Center Hall Remodel Questions & Answers

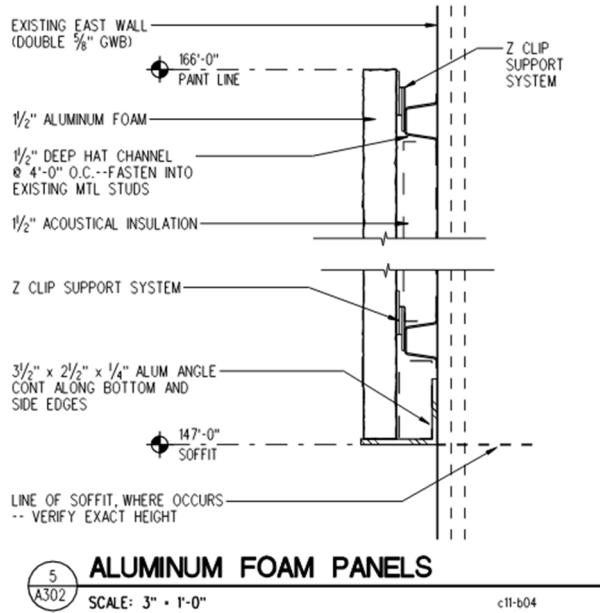
Question: *How is the allusion panel attached to the wall?*

Answer: The panels are attached with a 1 1/2" deep hat channel @4'-0" O.C. fastened into existing metal studs. Here is a detail from the 2009 Renovation documents:
